TECHNICAL NOTE

Reference: P0555t03v01

RE: Revised Responses to Submissions – Ivanhoe Estate Stage 1, Macquarie Park (SSD 8903)

Figure 1: Main Street / Lyonpark Road SIDRA Intersection Layout

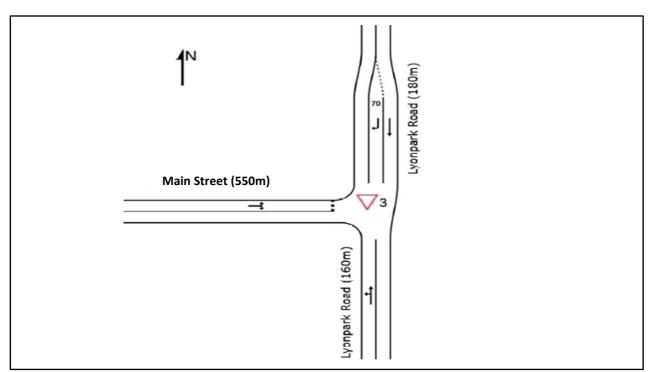
The proposed T-intersection at the termination of the new road connection to Lyonpark Road will form a bottleneck, and importantly, present hazardous and safety issues for patrons seeking to turn right onto Lyonpark Road.

Notwithstanding, further intersection modelling has been undertaken to assess the capacity of the Main Street and Lyonpark Road intersection during the AM and PM peak periods for the 2021 scenario. The existing priority controlled intersection performed acceptably in the 2021 scenario. However, the preferred layout option shown in **Figure 1** incorporates a 70m dedicated right turn bay into Main Street and has a separate southbound through lane. The results shown in **Table 4** demonstrate that the intersection continues to operate with a good level of service with the addition of the proposed development.

The future Lyonpark Road / Main Street intersection has been assessed and appropriate traffic control measures recommended given the volume of traffic this intersection is forecast to carry.

The NSW crash data from the Road Safety website has also been interrogated for the past five years and there have been no crashes in the vicinity of the proposed intersection or along Lyonpark Road from Epping Road to Byfield Street. The location has good sight distance, delineation, road geometry and traffic volumes and speeds are not considered to be high risk. Further, the intersection will be designed in accordance with the appropriate guidelines and standards to ensure the safest possible design for all road users.
